Board of Adjustment

June 17, 2020

CITY OF LOUISVILLE
BOARD OF ADJUSTMENT
STAFF REPORT
June 17, 2020

REQUEST: **Case #VAR-0302-2020** – Request for a variance from the Residential-Low zone district standards to allow:

Proposed Elevations

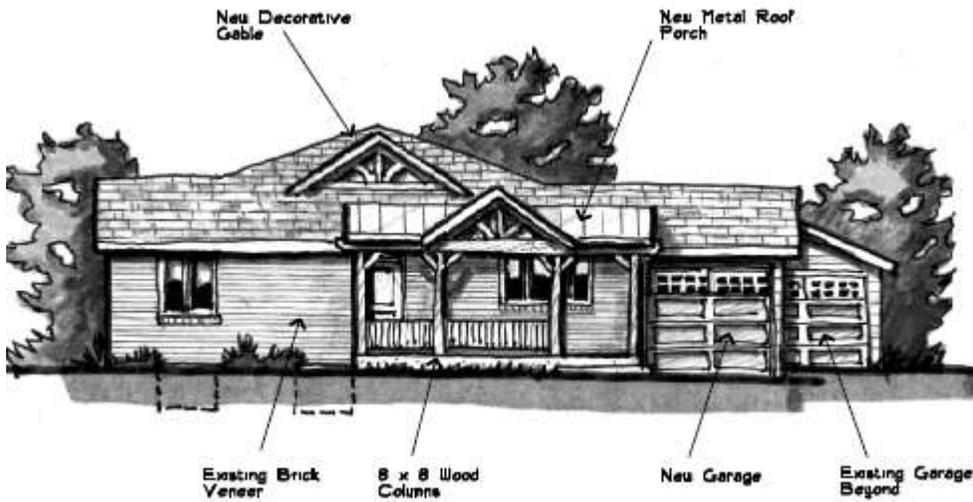
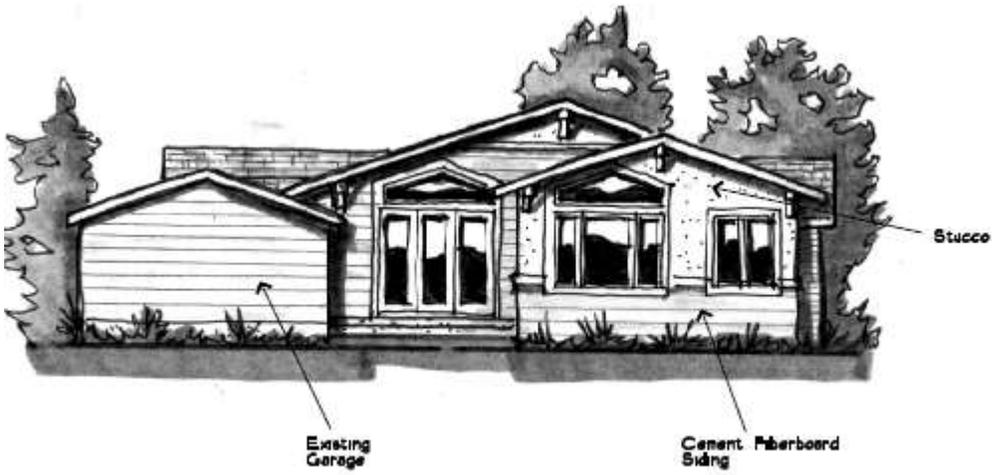
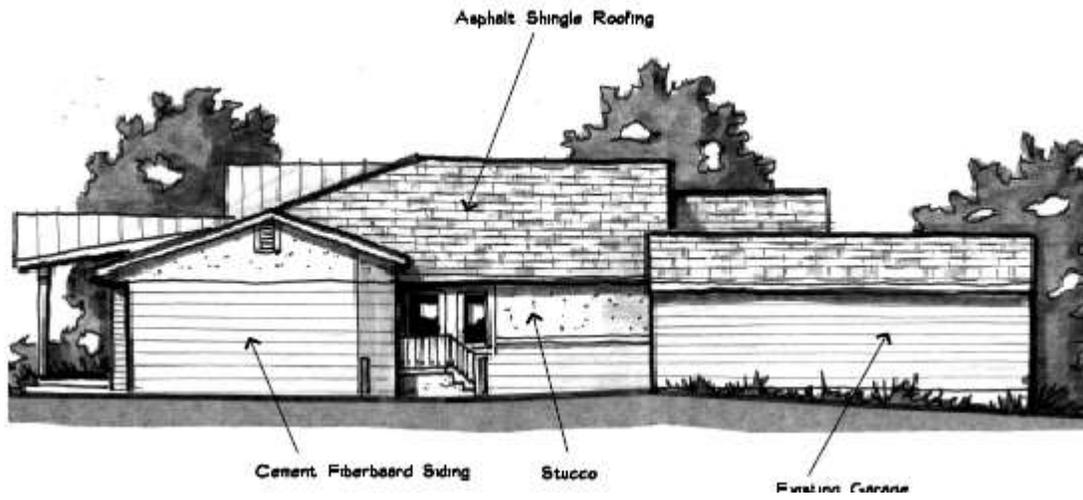
Staff finds that the property can reasonably be developed in conformity with the provisions of Title 17 with respect to lot coverage and the side and rear setback portions of the application. The RL zone district allows 35 ft in height for a principal structure, which could accommodate a second floor addition to the existing structure to provide the desired expansion to the home. Additionally, the applicant could not attach the addition to the

detached garage and keep it entirely within principal structure setbacks. Staff finds the request for reconstruction of the front porch is reasonable due to the existing nonconforming status and the front setbacks of neighboring properties. However, in totality this application does not meet this criterion. **Staff finds the proposal does not meet this criterion.**

Staff finds that the proposal will alter the essential character of the neighborhood, as it will result in a lot coverage of 40%, when the maximum allowed by zoning is 30% and largest lot coverage currently existing along Rose Street at 26.5%. Staff notes that the proposal for the front elevation of the home is not visibly larger than what exists currently. The detached garage is currently in place, and the addition connecting this to the principal structure is necessitating the side and rear setback requests. The neighbors to the north and south have included letters of support for this request. **Staff finds the proposal does not meet this criterion.**

Staff finds that the proposal is not the minimum variance that will provide relief. Staff believes there are reasonable alternatives, such as an unenclosed breezeway connecting the garage to the home that provides shelter from weather that removes the need for the side and rear setback requests. The lot coverage could be reduced to meet the RL zone district standard of 30% and still allow additional development on the property. **Staff finds the proposal does not meet this criterion.**

Staff finds the proposal does not meet the applicable variance criteria in Section 17.48.110 of the LMC, and therefore, recommends denial of the variance request.
